SYSTEMATIC EVALUATION PROGRAM
STATUS REPORT AND INITIAL EVALUATION

MHB TECHNICAL ASSOCIATES
1723 HAMILTON AVENUE
SAN JOSE, CALIFORNIA 95125

SWEDISH NUCLEAR POWER INSPECTORATE

JUNE 1983

Figure 1

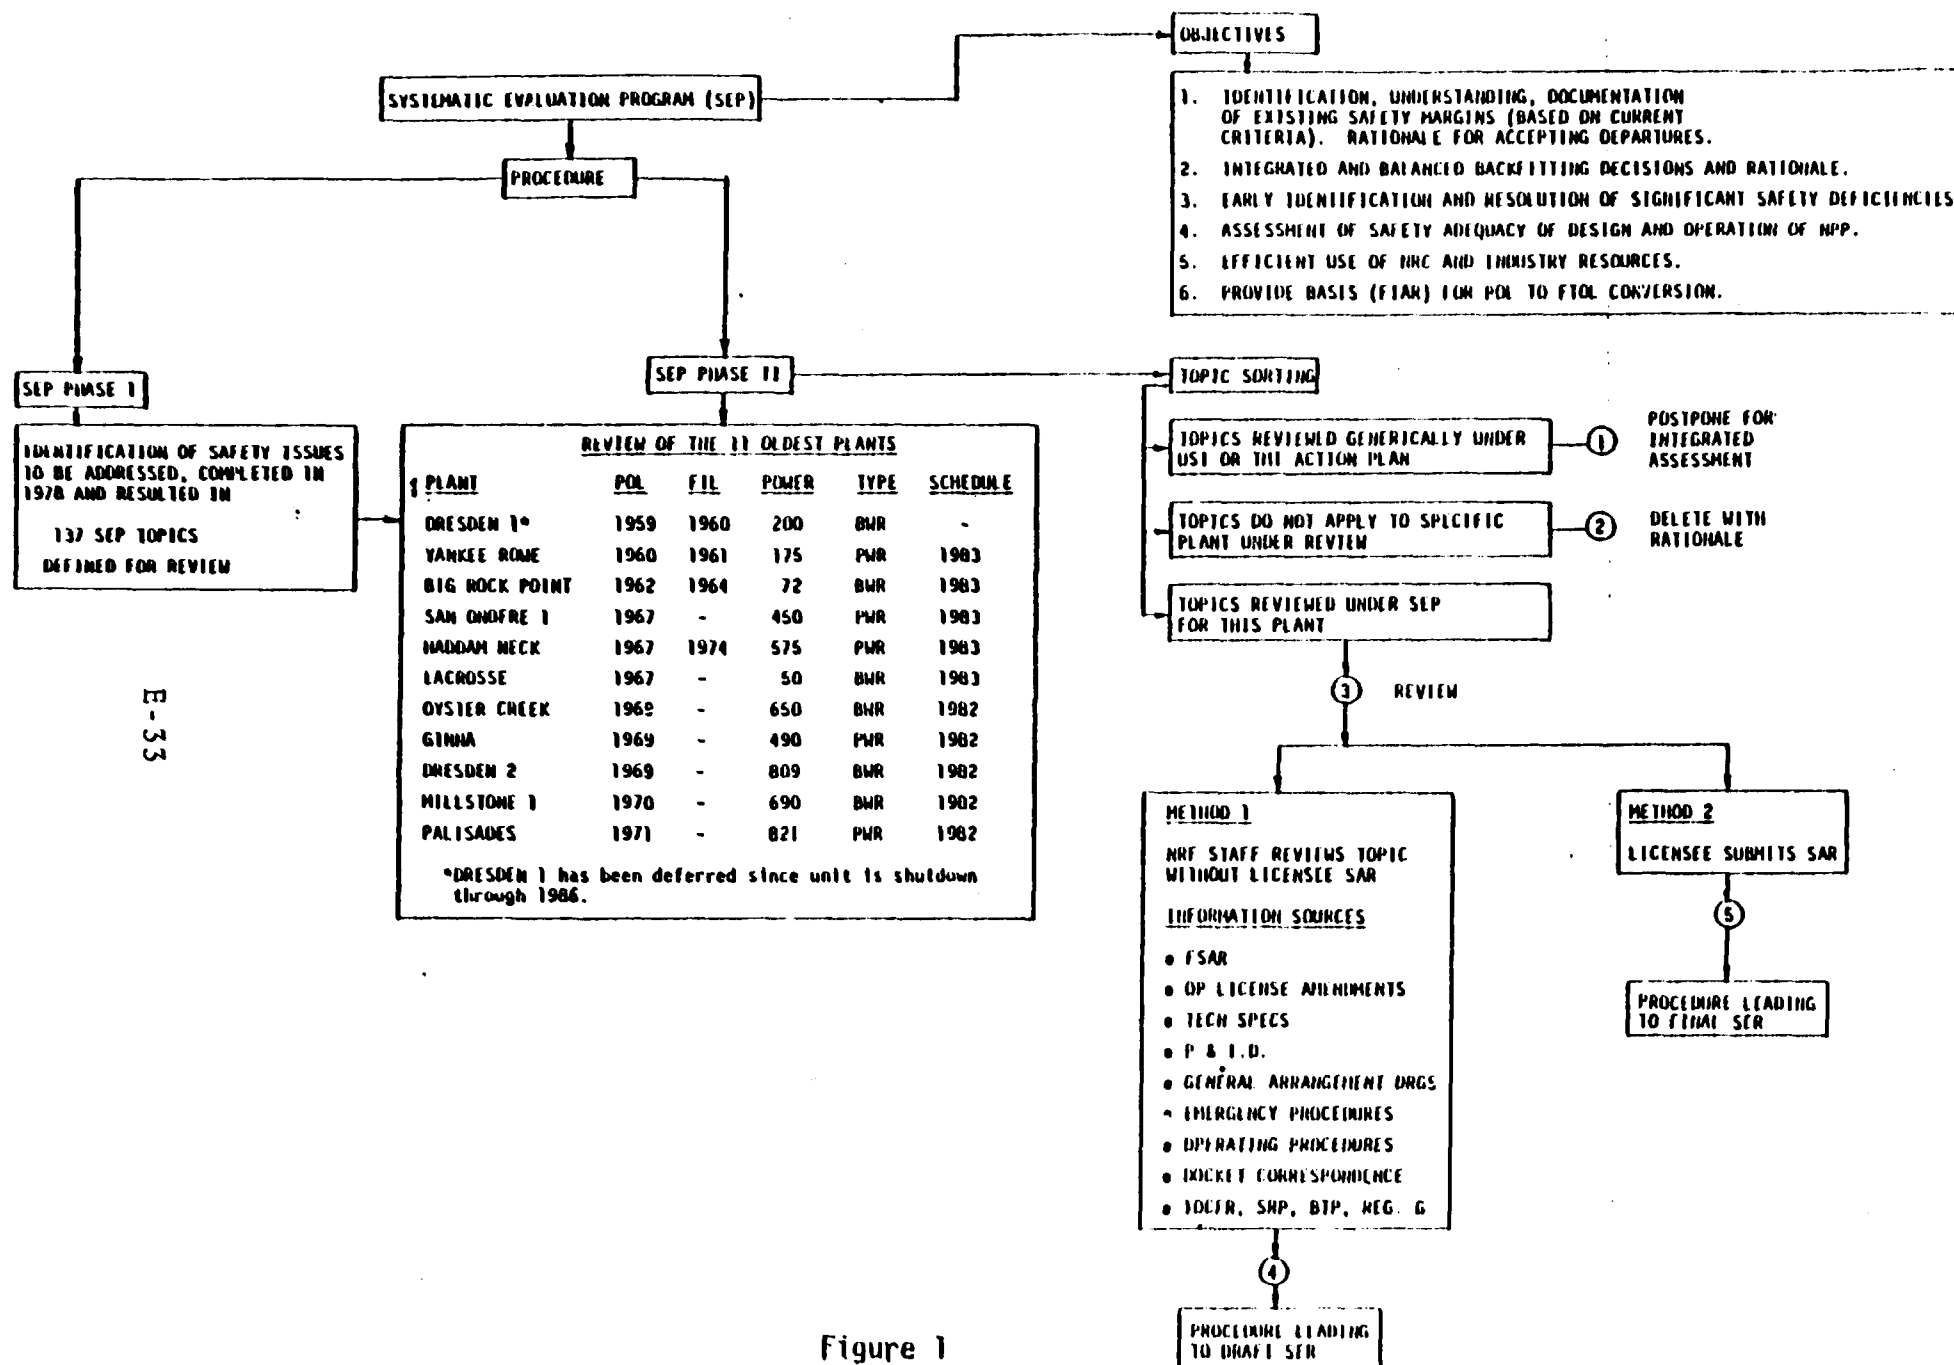
SEP review for Palisades, NUREG-0820, is comprehensive and engineering arguments are sound. Following this procedure, Figure 1, 24 topics exit at (1) identified as generic items related to USI and TMI Action Plan, 23 topics exit at (2) because these are not applicable to Palisades and 90 topics exit at (3) where the actual review of SEP topics for Palisades begins. It is not identified in NUREG-0820 how many topics were handled by Method 1 and how many by Method 2. However, at the step A (Disposition of Topics), all but 31 were left for backfit candidacy, the remaining 59 having been put in one of the categories 1 to 3. None of the topics fell in the category 4 (i.e., safety significant departure), requiring prompt action. I find that technical arguments leading to distribution of topics to various categories are acceptable.
